## Agenda Item #: 4

### SUB-002700-2023 & MOD-002781-2023

- Subdivision approval to create two (2) legal lots of record
- Modification of a previously approved Planned Unit Development

APPLICATION NUMBER <u>      4      </u> DATE <u>      January 18, 2024      </u>	 NTS
APPLICANT <u>      College Park Northwestern Quadrangle Sub, Unit 2, Resub of Lots 1-A &amp; 1-B into Lots 1-A-1 &amp; 1-B-1      </u>	
REQUEST <u>      Subdivision, PUD Modification      </u>

# SITE PLAN

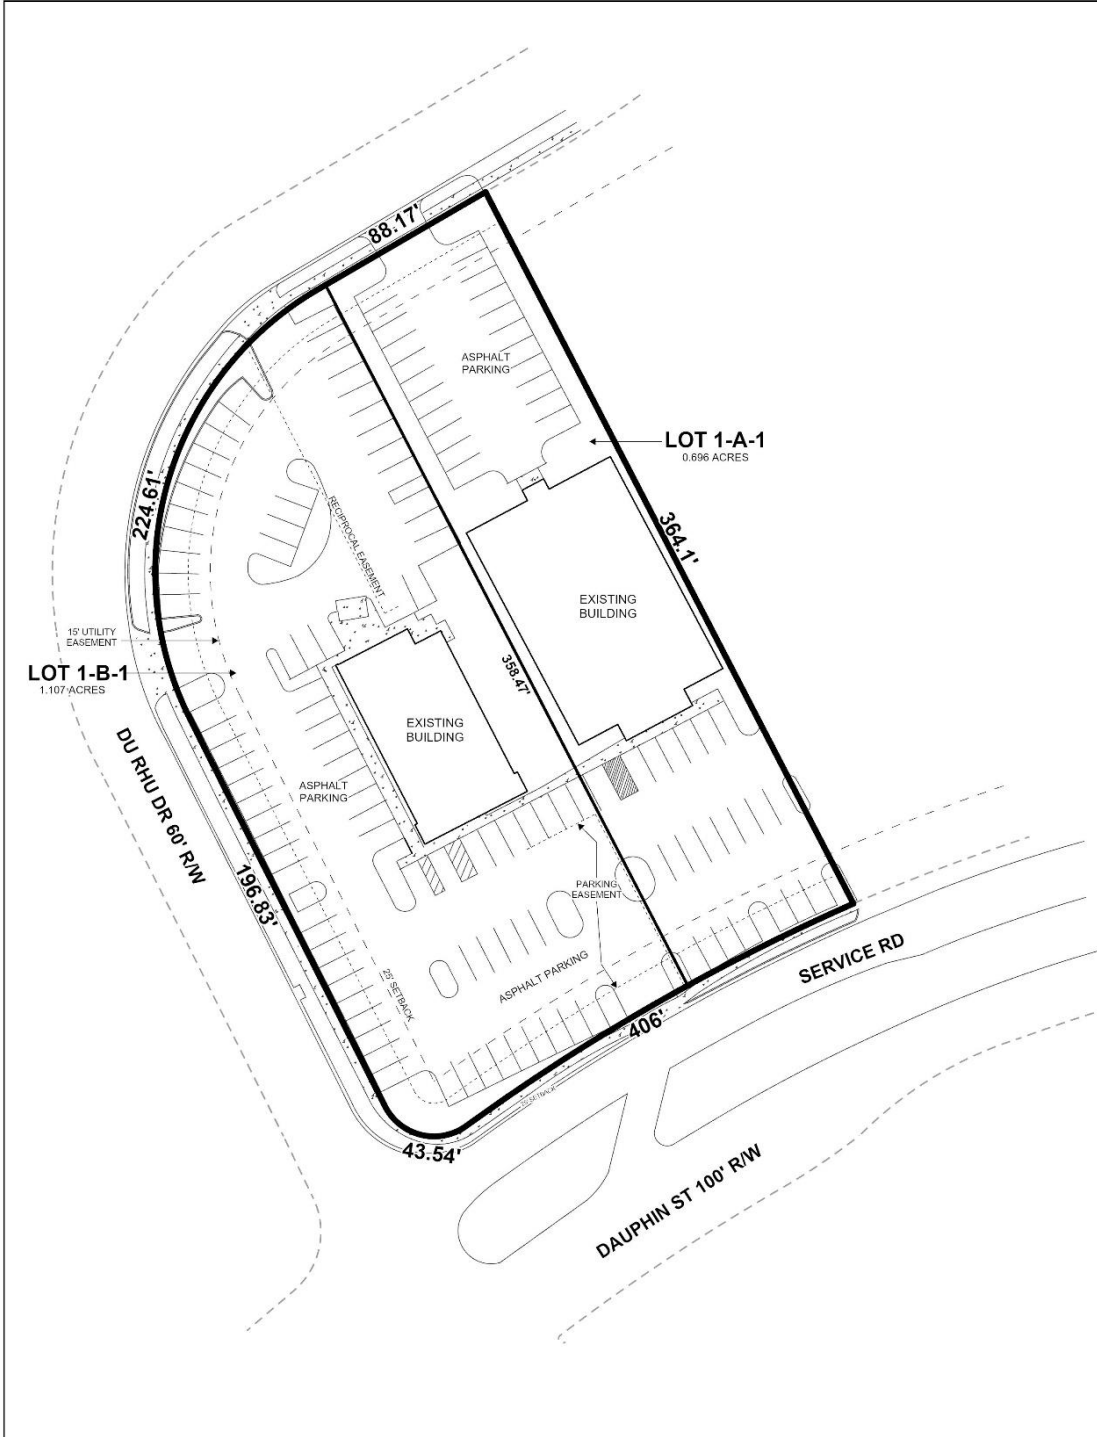
1. Revise the drawing name from RESUBDIVISION to PUD Site Plan.

2. Delete the three (3) City signature blocks, Surveyor Certification, and the other unnecessary items from the Site Plan.
3. Add the following notes to the PUD Site Plan:

The site plan reflects the changes proposed by the Subdivision request, and illustrates that both proposed lots are developed with buildings and associated parking facilities. If approved, the PUD site plan should be revised to reflect any revisions to easements as detailed in the Subdivision Planning Comments above.

It should be noted that, while parking is illustrated, no information is provided for staff to verify the site has an adequate number of parking spaces. As such, if approved, revision of the site plan to provide a table noting the off-street parking requirements of Table 64-3-12.1 of Article 3 of the UDC for each use of the site should be required, along with the number of parking spaces provided.

The size of each proposed lot is depicted in both square feet and acres and should be retained on the Final PUD site plan, if approved. The PUD site plan does not provide the size of existing commercial structures in square feet as required by Article 10 Section 64-10-3.E.3(c) of the UDC. As such, the Final PUD site plan should be revised to provide this information.

It should be noted that future development or redevelopment of the proposed lots may require additional modifications of the PUD to be approved by the Planning Commission and City Council. A note stating as much should be placed on the recorded site plan, if approved.

1. Revision of the Final PUD site plan to reflect any/all revisions to easements as a result of the associated Subdivision request;
2. Retention of a note on the Final Plat stating no structures shall be constructed in any easement without permission from the easement holder;

3. Revision of the site plan to provide a table noting the off-street parking requirements of Table 64-3-12.1 of Article 3 of the UDC for each use of the site, along with the number of parking spaces provided;

5. Retention of the lot size labels in both square feet and acres, or provision of a table on the Final PUD site plan with the same information;
6. Provision of the building sizes in square feet on the Final PUD site plan;

7. Retention of the rights-of-way along all streets on the Final PUD site plan;
8. Provision of a note on the Final PUD site plan stating future development or redevelopment of the property may require approval by the Planning Commission and City Council;
